Drawing of enclosure for Lion-tailed macaque at the Pilikula Biological Park, Mangaluru, Karnataka received vide letter dated 22.08.2017 from the Zoo Director is found in compliance with observations made by the Expert Group on Zoo Designing, Central Zoo Authority in its 74th meeting held on 13th & 14th July, 2017 vide Agenda Item No. 3(I)(A). While construction of enclosures, structural stability of the enclosures should be ensured by the concerned Structural Engineer.

PROPOSED PLAN OF LION TAILED MACAQUE ENCLOSURE IN PILIKULA BIOLOGICAL PARK AT DR SHIVARAMA KARANATHA PILIKULA NISARGA DHAMA MANGALURU

CROSS SECTION OF MOAT

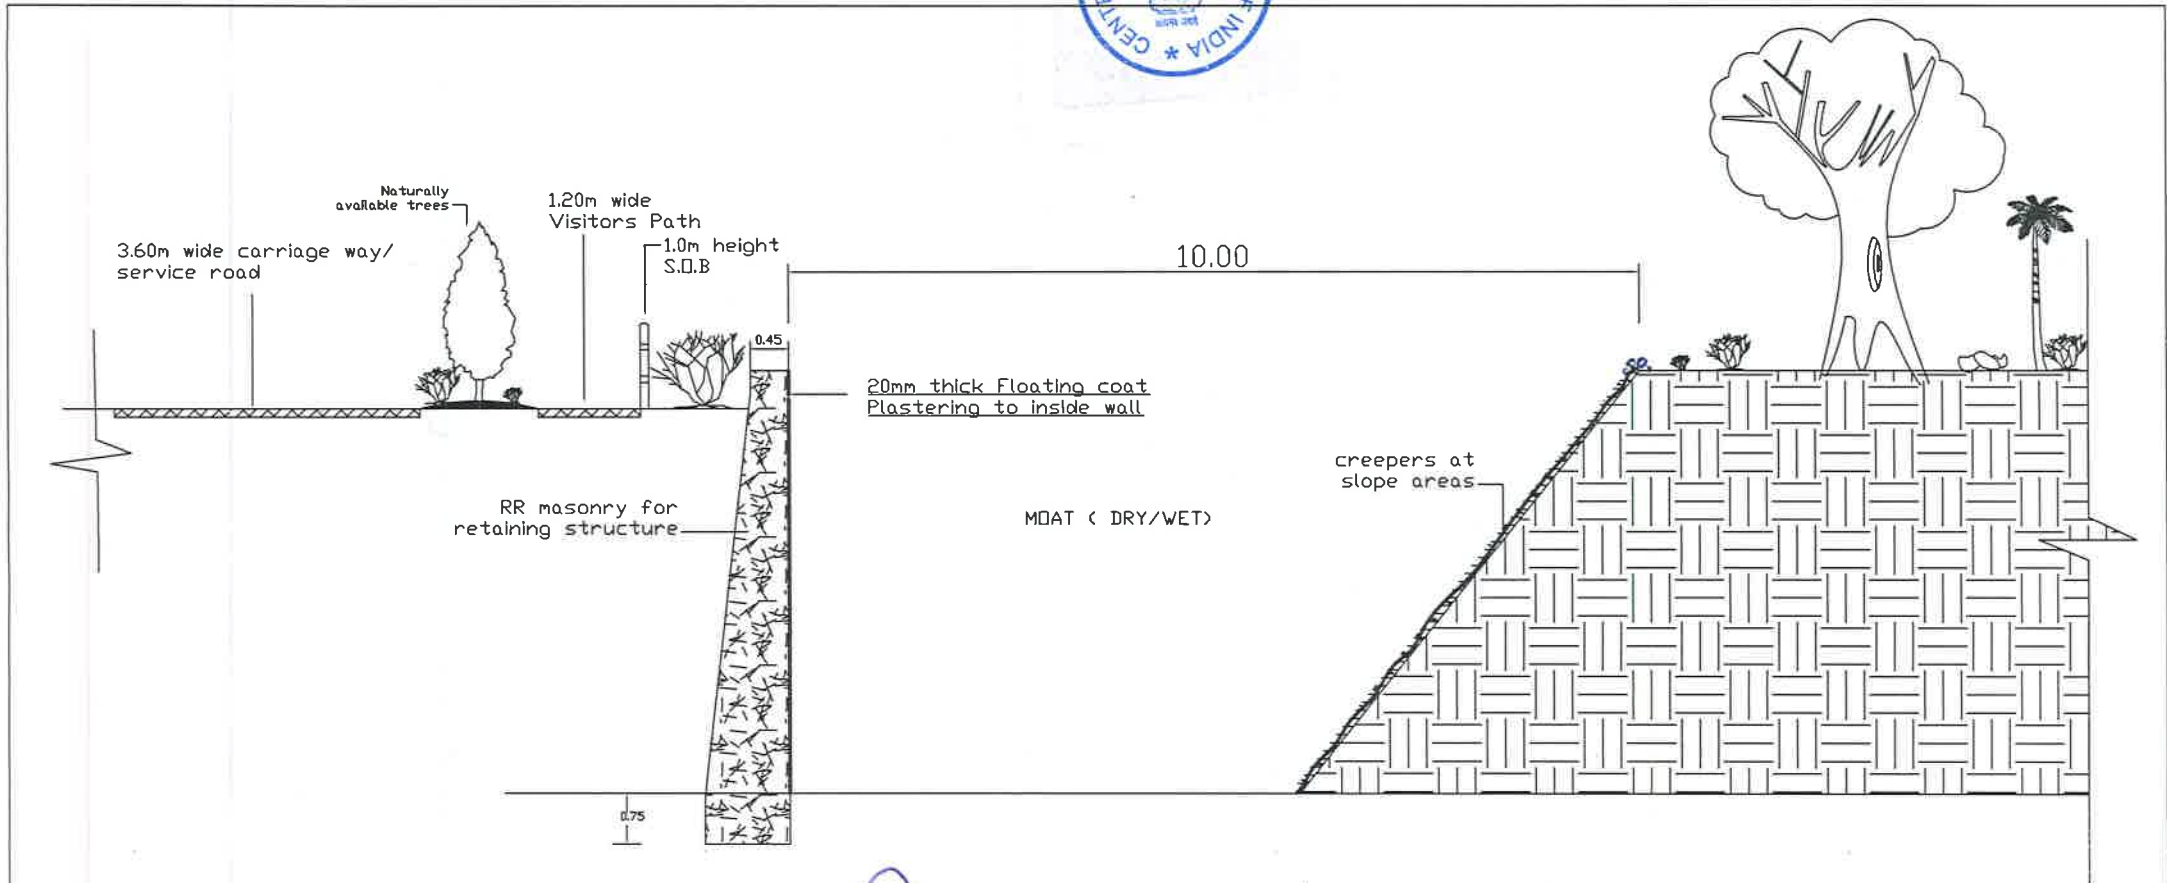
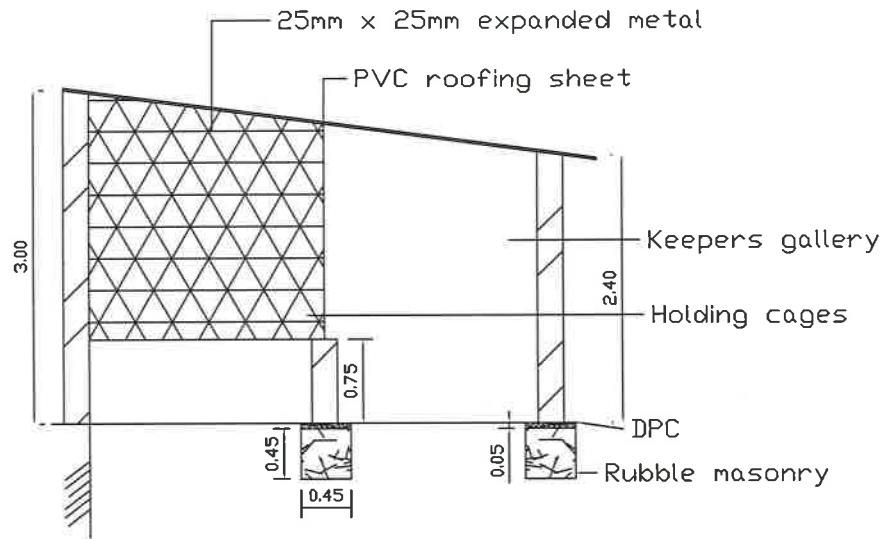
Drawing of enclosure for Lion-tailed macaque at the Pilikula Biological Park, Mangaluru, Karnataka received vide letter dated 22.08.2017 from the Zoo Director is found in compliance with observations made by the Expert Group on Zoo Designing, Central Zoo Authority in its 74th meeting held on 13th & 14th July, 2017 vide Agenda Item No. 3(I)(A). While construction of enclosures, structural stability of the enclosures should be ensured by the concerned Structural Engineer.

PLAN

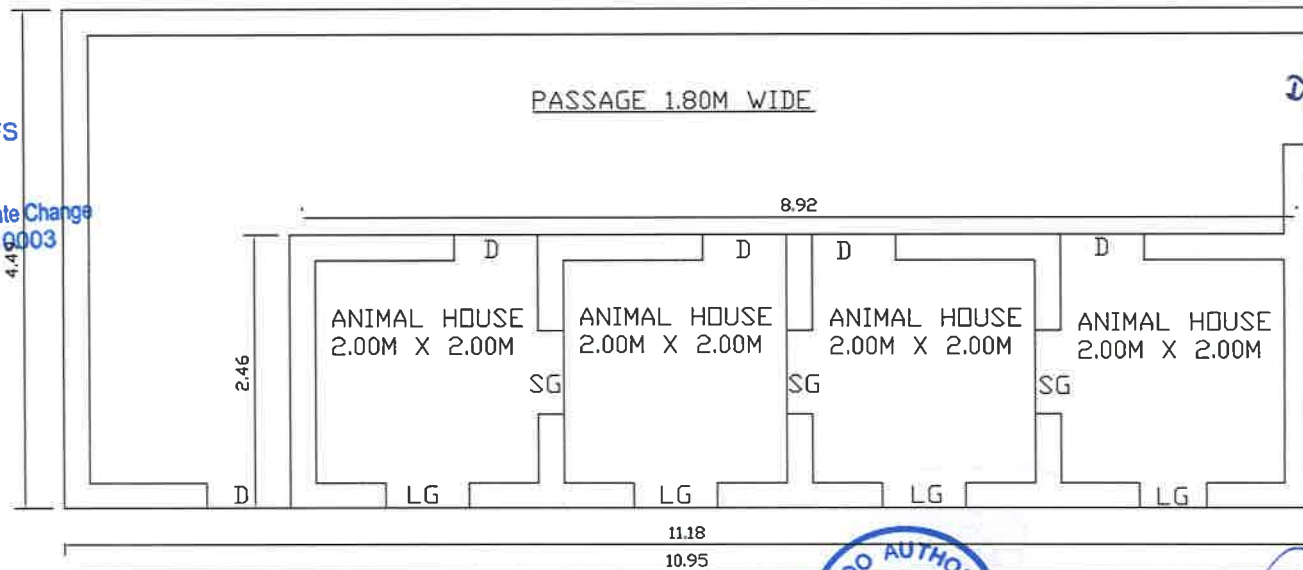
Drawing of enclosure for Lion-tailed macaque at the Pilikula Biological Park, Mangaluru, Karnataka, received vide letter dated 22.08.2017 from the Zoo Director is found in compliance with observations made by the Expert Group on Zoo Designing, Central Zoo Authority in its 74th meeting held on 13th & 14th July, 2017 vide Agenda Item No. 3(1)(A). While construction of enclosures, structural stability of the enclosures should be ensured by the concerned Structural Engineer.
